**CITY OF NORTH ST. PAUL PLANNING COMMISSION  
REGULAR MEETING AGENDA  
THURSDAY, AUGUST 13TH, 2020  
6:15 PM**

Date: 8/11/2020  
To: Planning Commissioners  
From: Erin Perdu, AICP, City Planner  
Morgan Dawley, PE, City Engineer  
CC: Scott Duddeck, City Manager  
Re: Preliminary/Final Planned Unit Development, Site Plan Review and Preliminary/Final Plat for development of 12 townhouse units at the Intersection of Delaware Avenue and 17<sup>th</sup> Avenue (2329 17<sup>th</sup> Avenue E).

Paul Bruggeman is requesting approval of a Preliminary/Final Planned Unit Development (PUD), Site Plan, and a Preliminary/Final Plat to facilitate the development of a revised concept (October 2019) for 12 townhouse units at 2329 17th Avenue E. The subject site is a vacant, City-owned, 2.48-acre parcel.

SHEET:  
C3.0

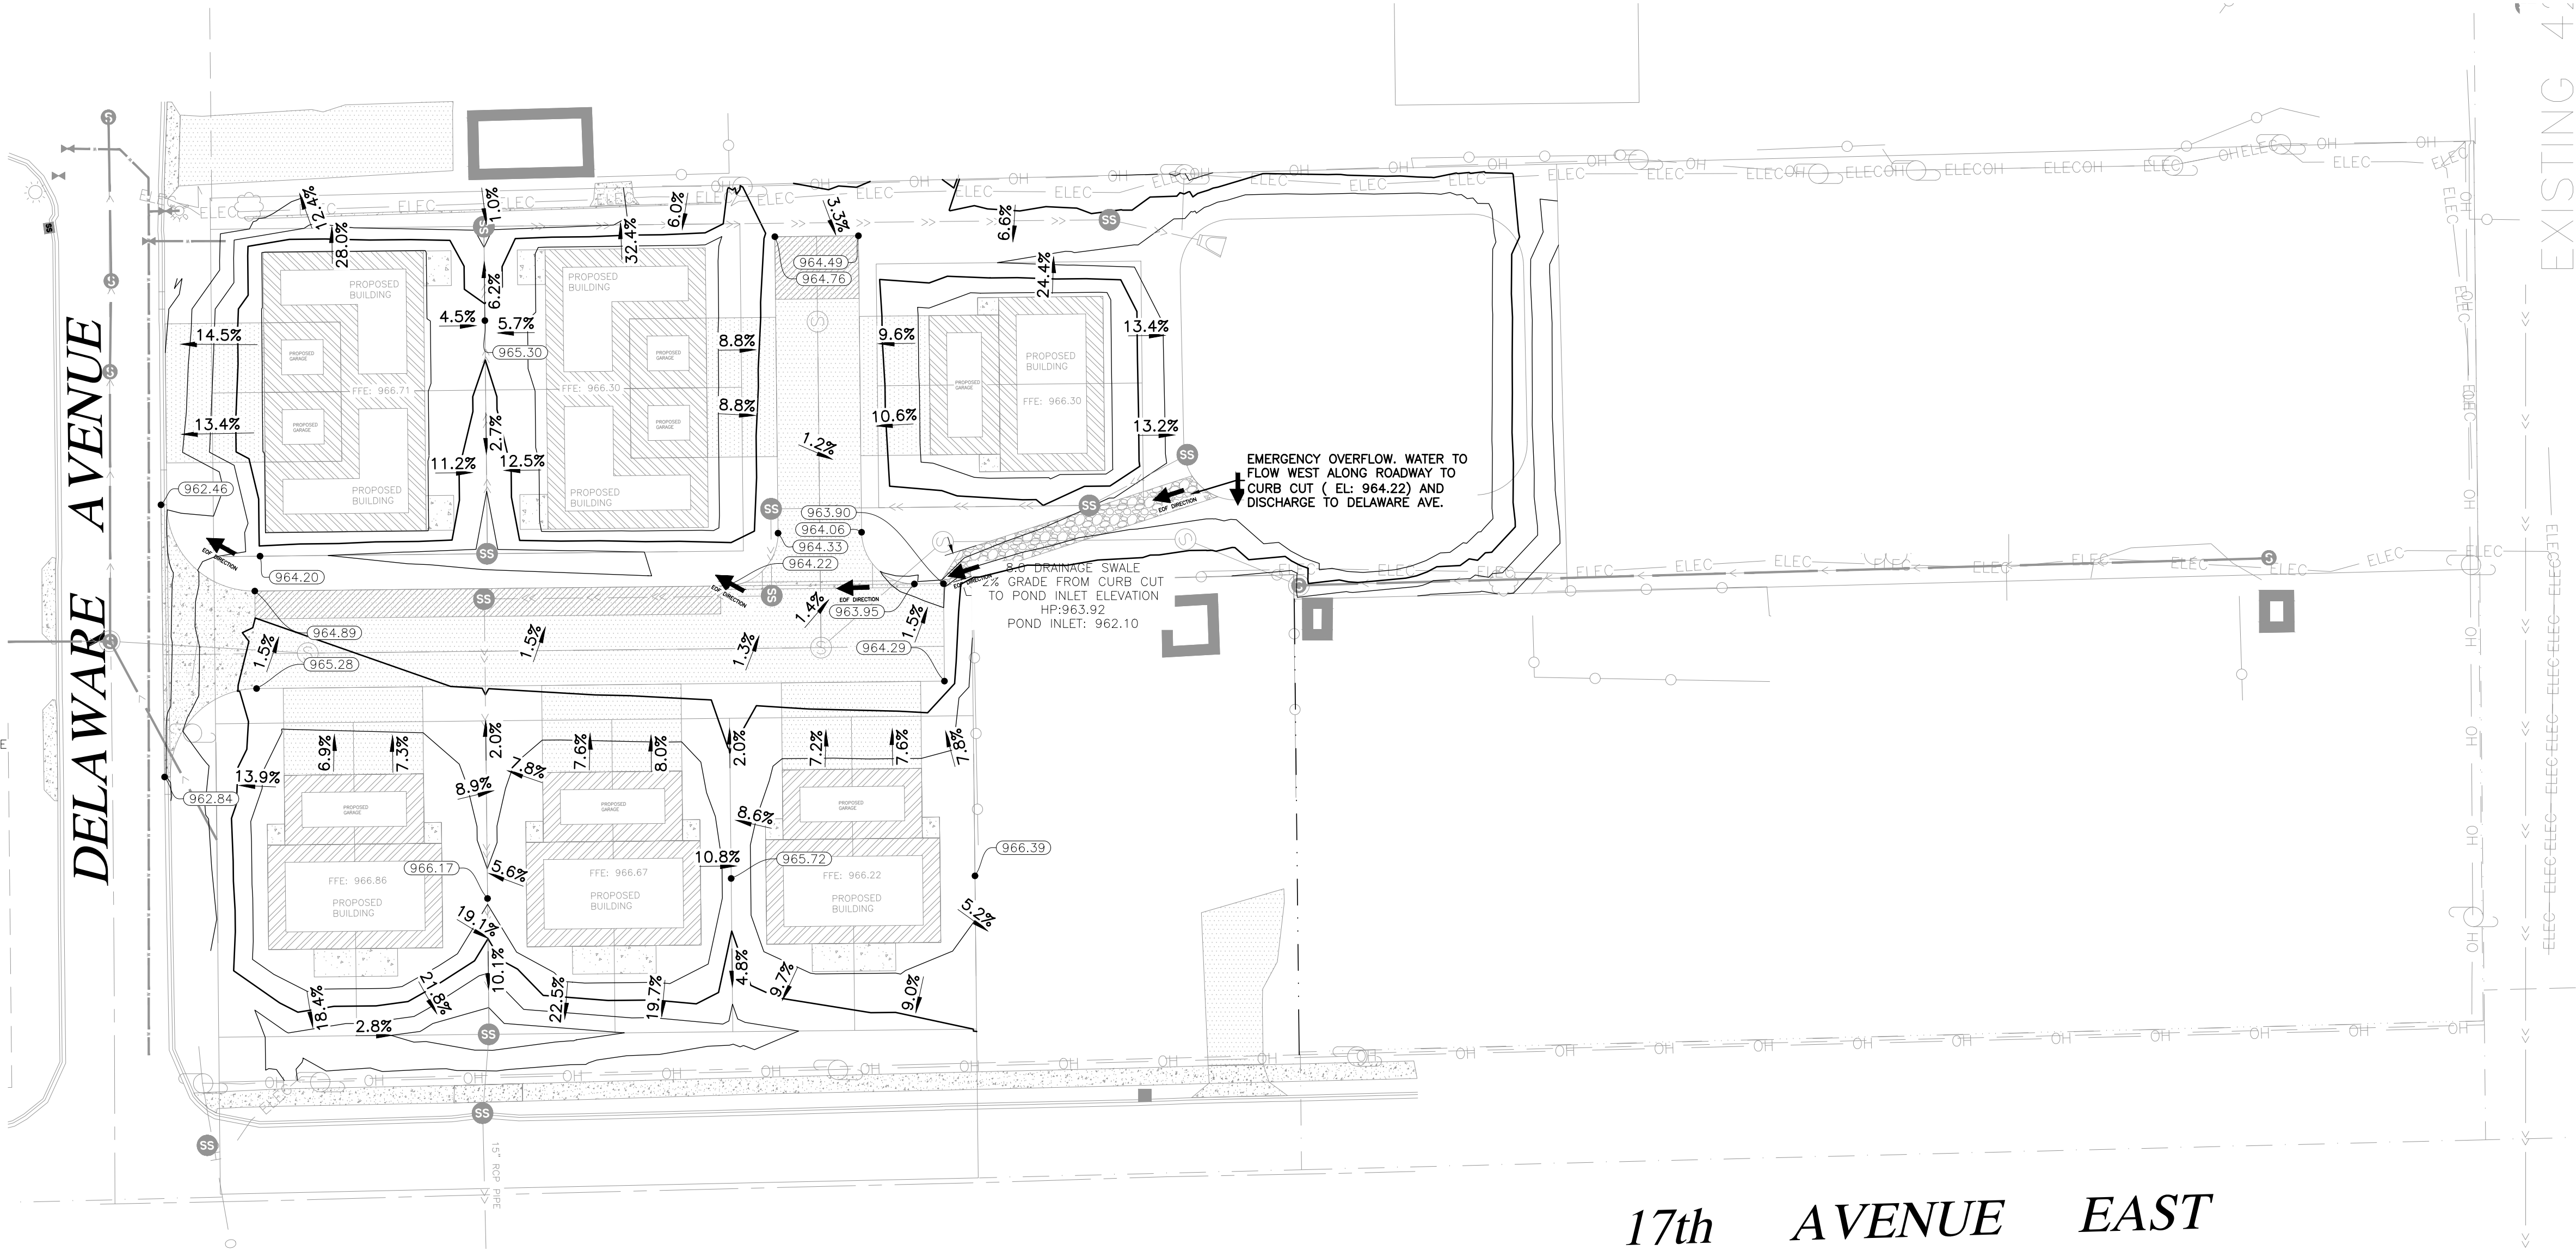
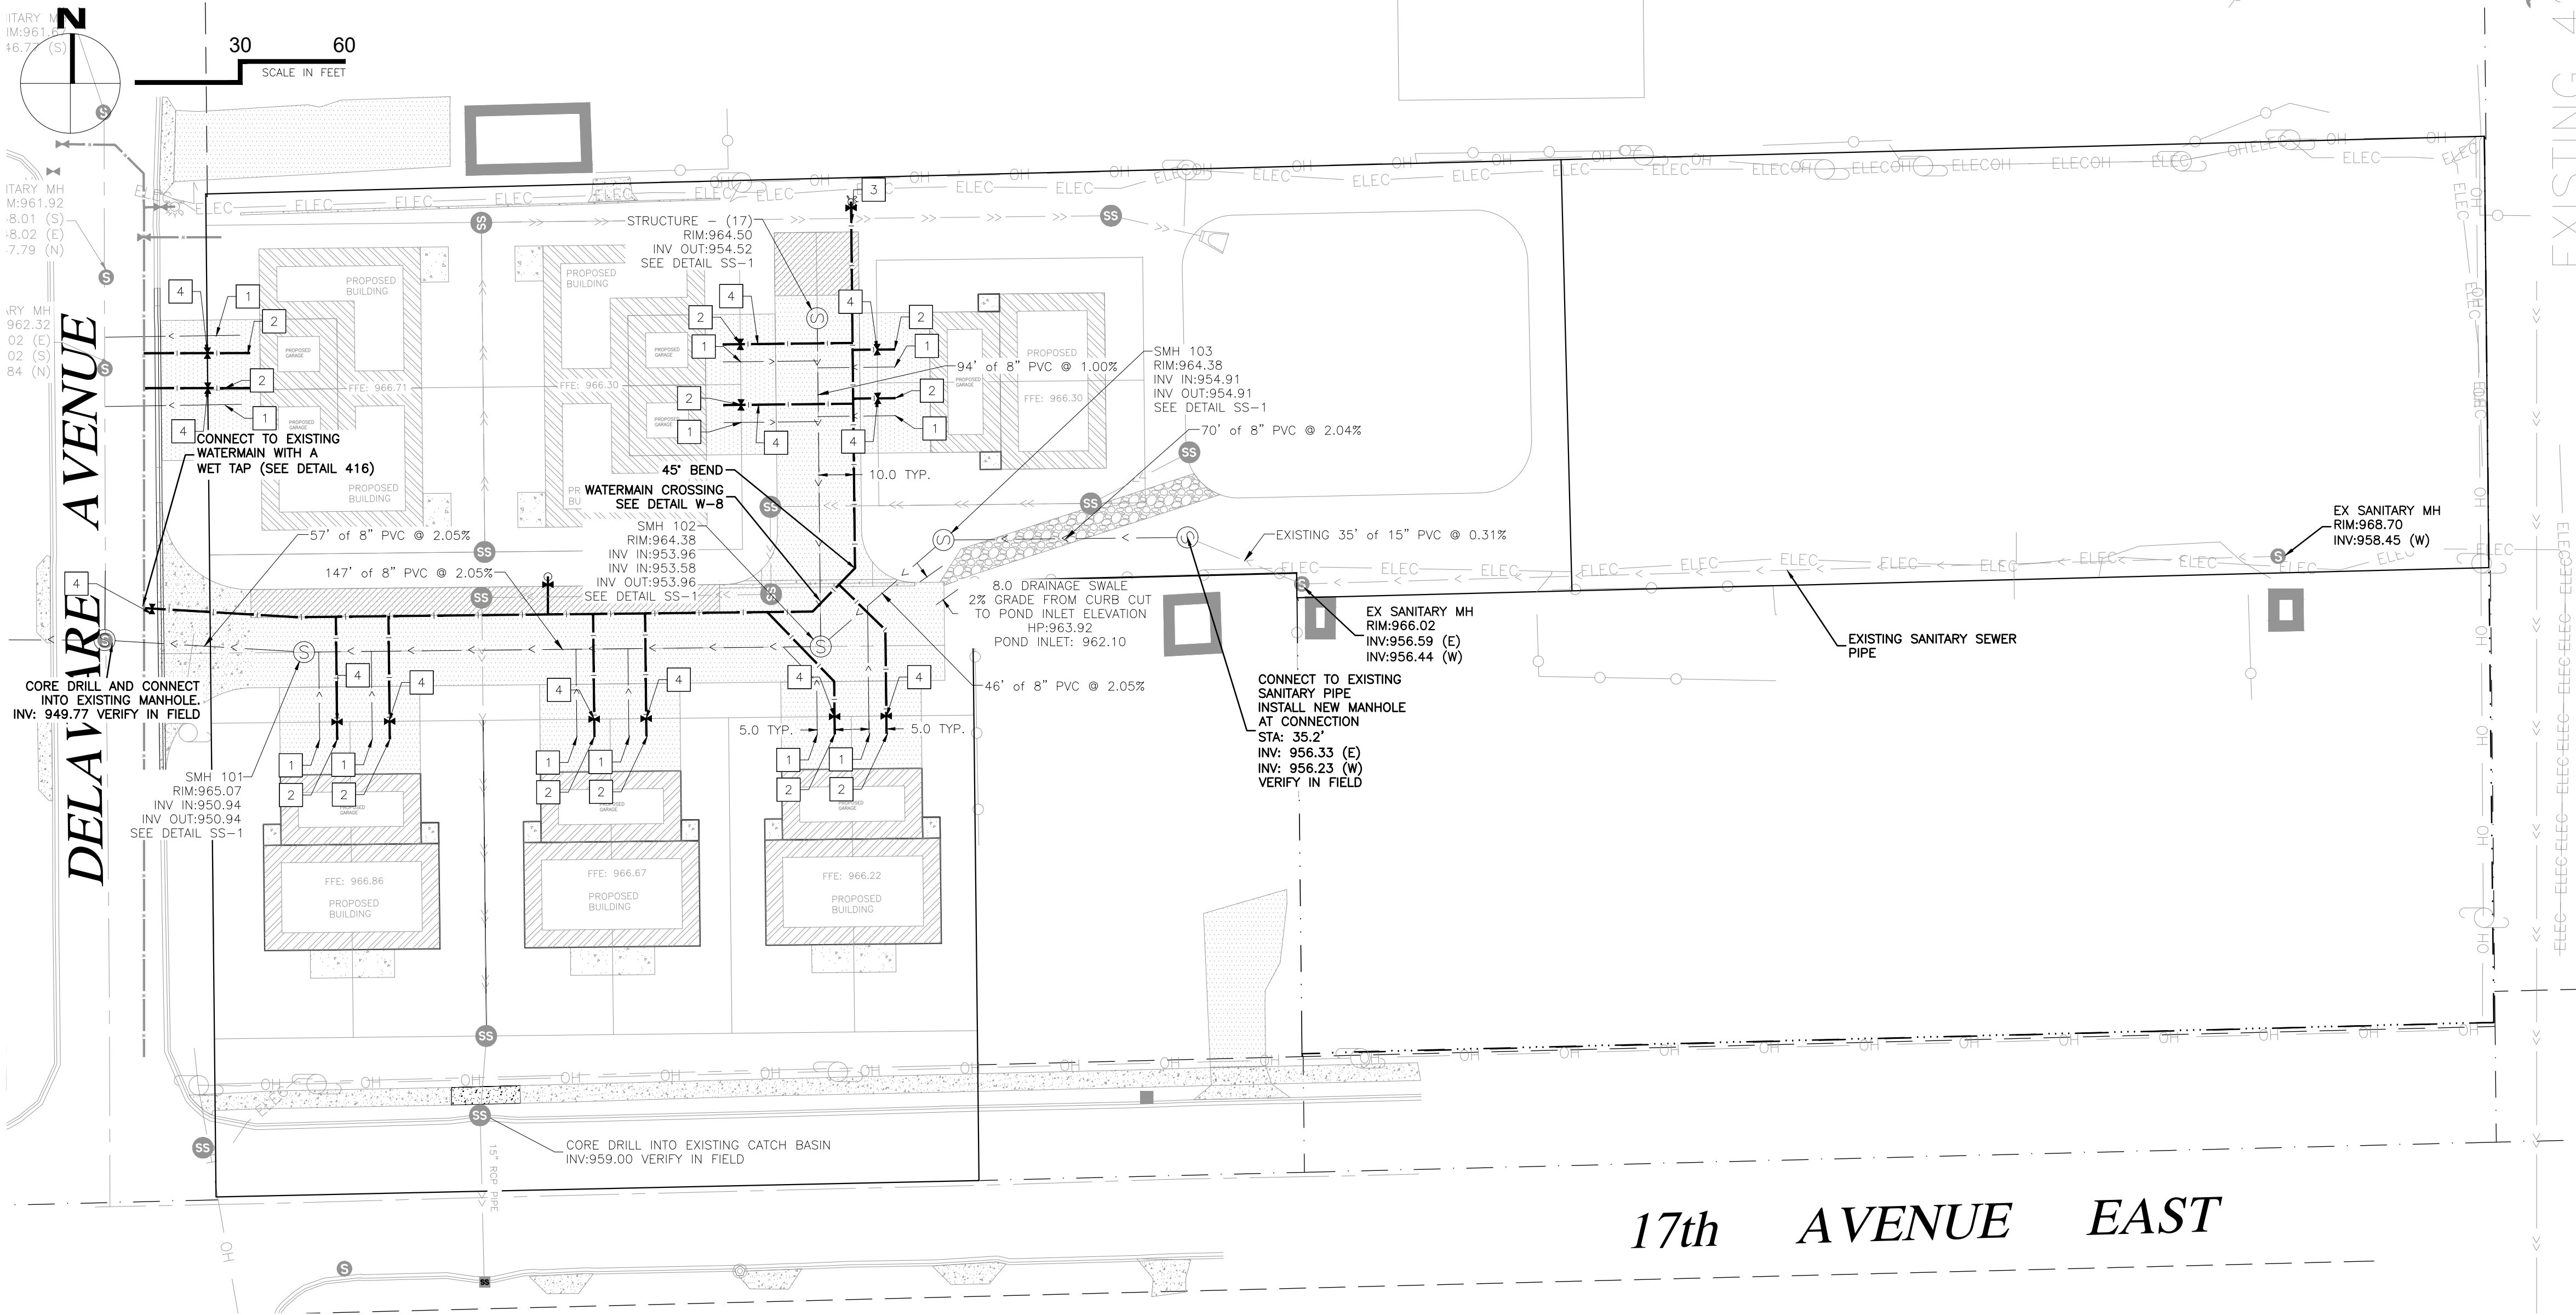
6. There are several areas where the surface grades are proposed to be less than 2%. The applicant should modify the grades or provide how water will be adequately conveyed in these areas.

9. The site entrance/exit appears to have a grade of just under 7%. This may cause a hazard in the winter for cars attempting to enter and exit. A grade of 5% is recommended with a vertical curve and 0.5% immediately adjacent to Delaware Avenue. No profile was included in initial submittals to verify proposed grades.

25. Revise grades to bring all driveways exceeding 10 percent grade to 10 percent or less.

SHEET:  
**C5.0**

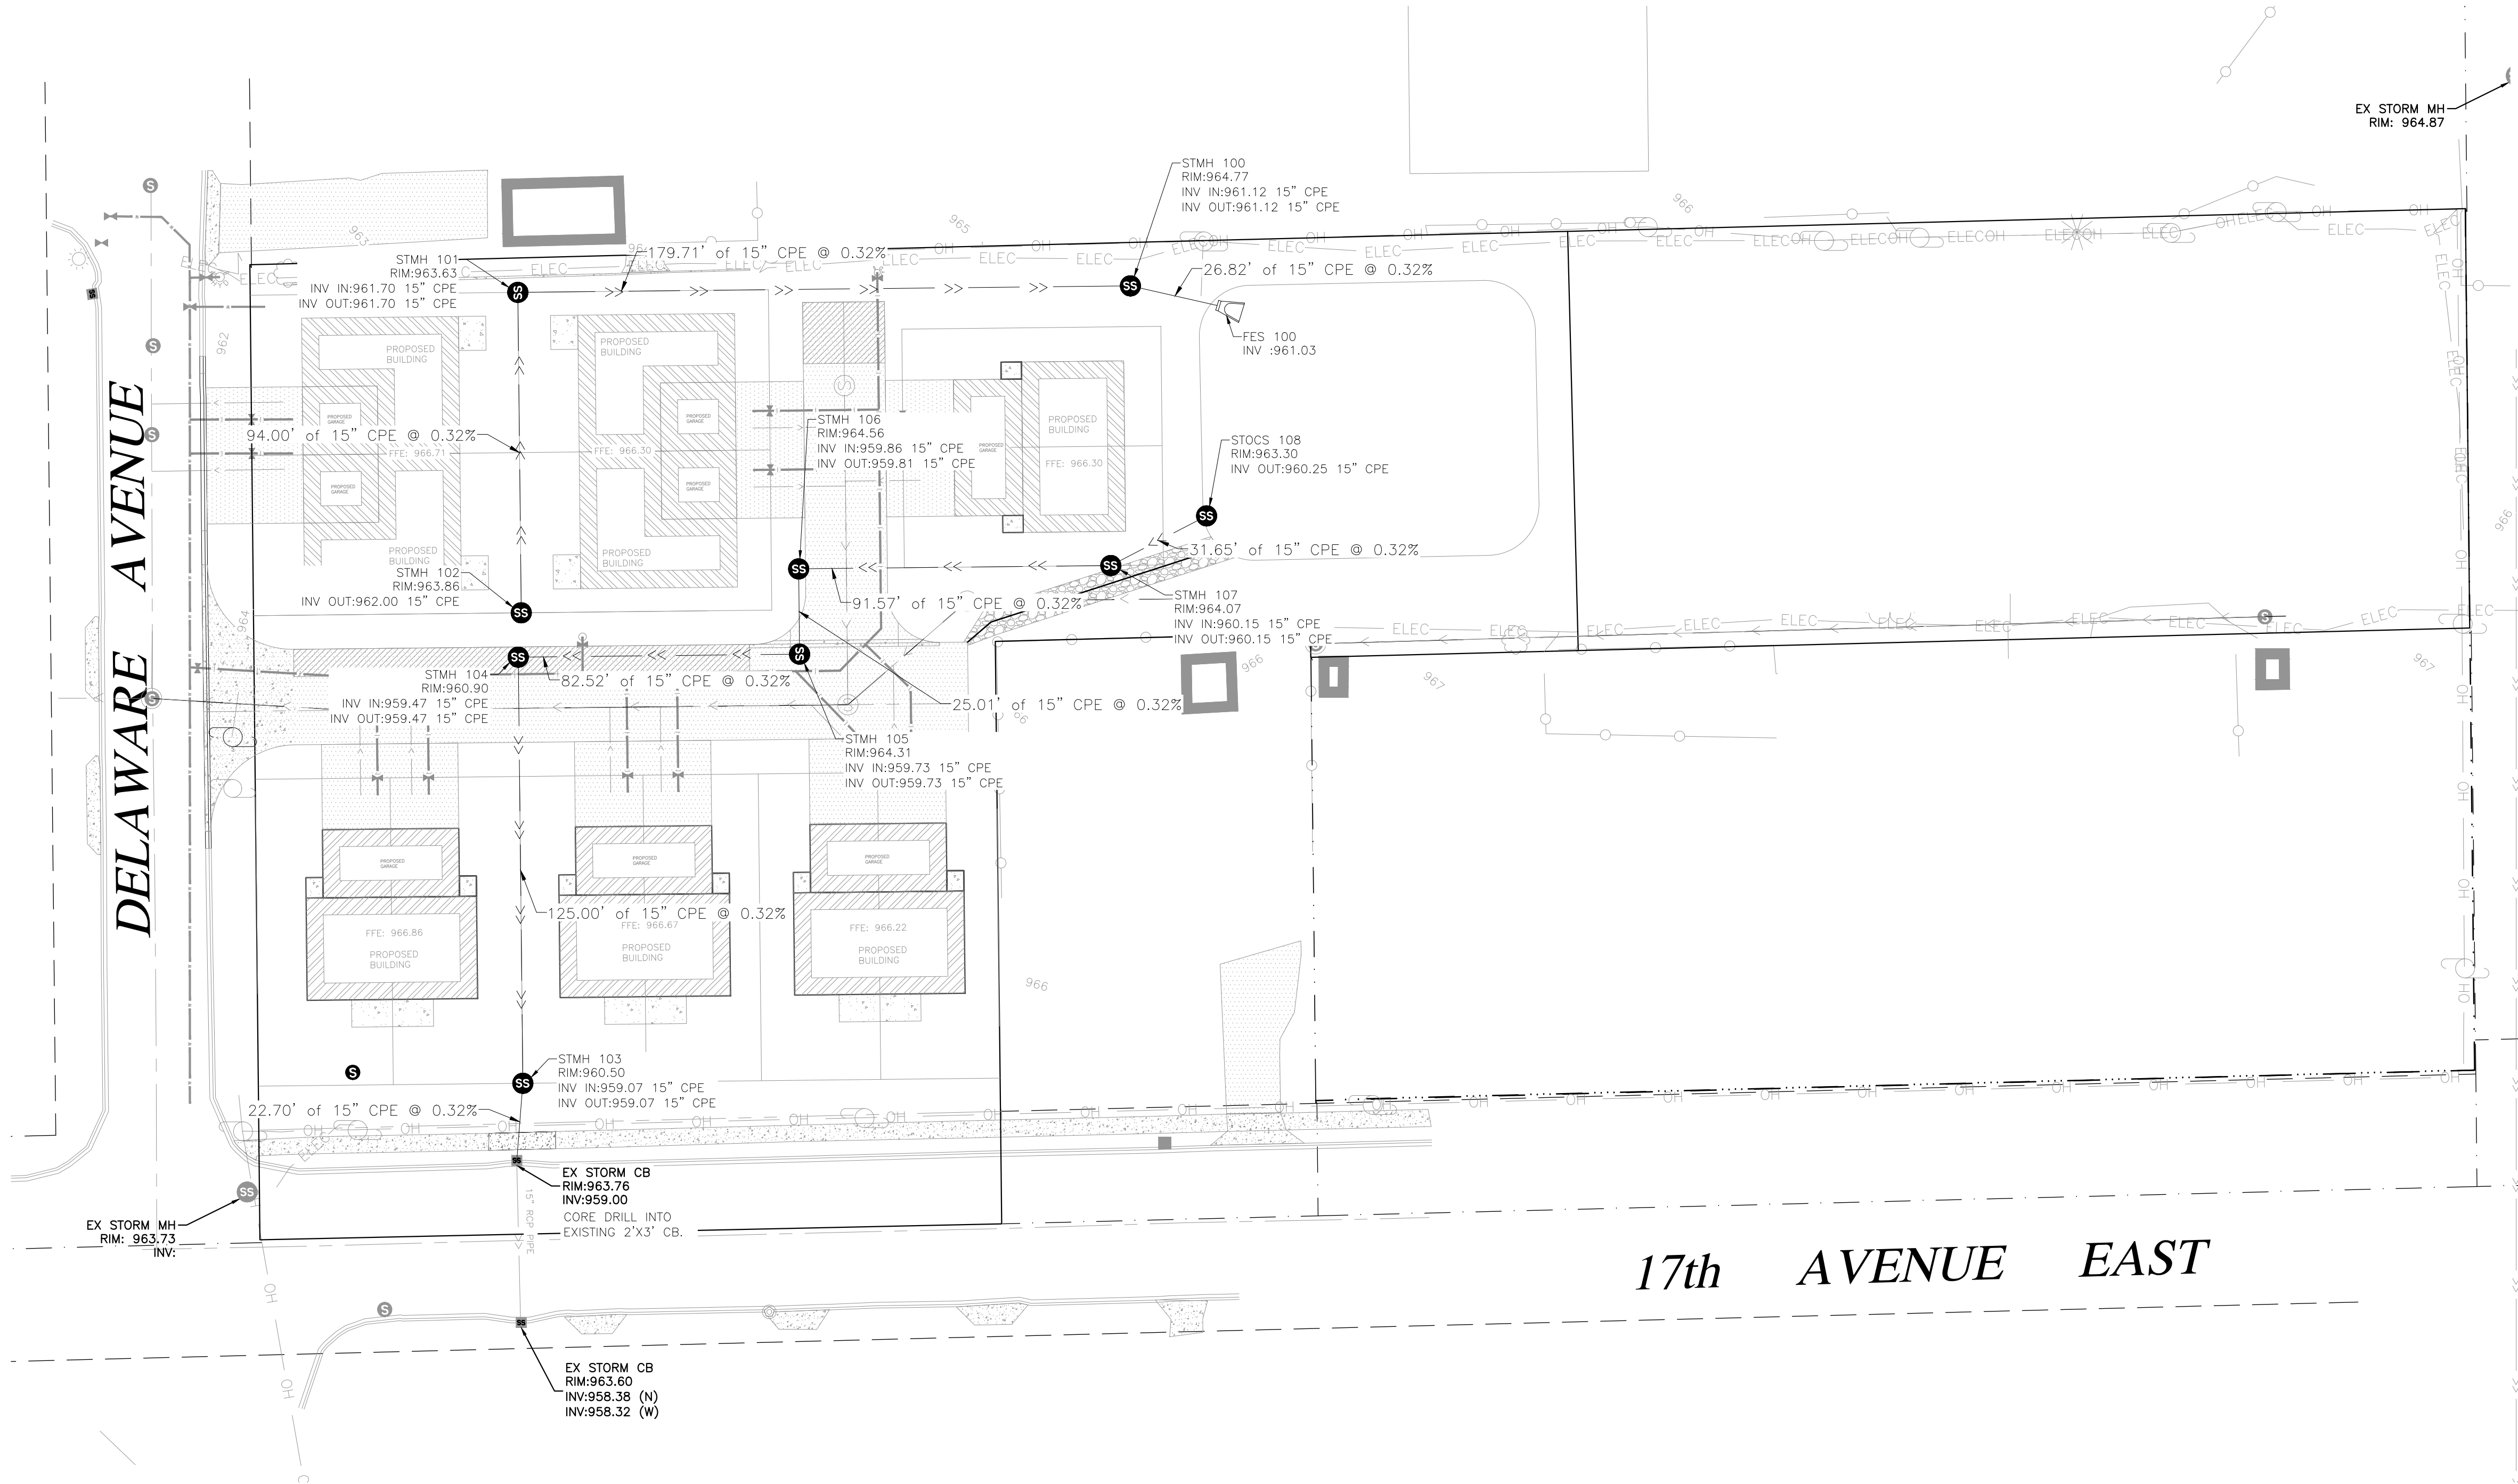
1. The applicant should revise the current sanitary sewer alignment to connect to the existing sanitary sewer manhole directly across from the site entrance. The existing sanitary services to the lots located south of the site should be shown as being reconnected to the last segment of proposed pipe at the east end. Applicant will need to maintain 10' horizontal and 18" vertical separation from all existing and proposed watermains with the revised alignment.

2. The watermain throughout the site will need to be 8" PVC C900. Applicant will need to maintain 10' horizontal and 18" vertical separation from all existing and proposed sanitary and storm sewers with the revised alignment.

3. Easements on final utility plans and final plat shall be wide enough to allow for a 1:1 working trench with a minimum of 20' centered on the utility.
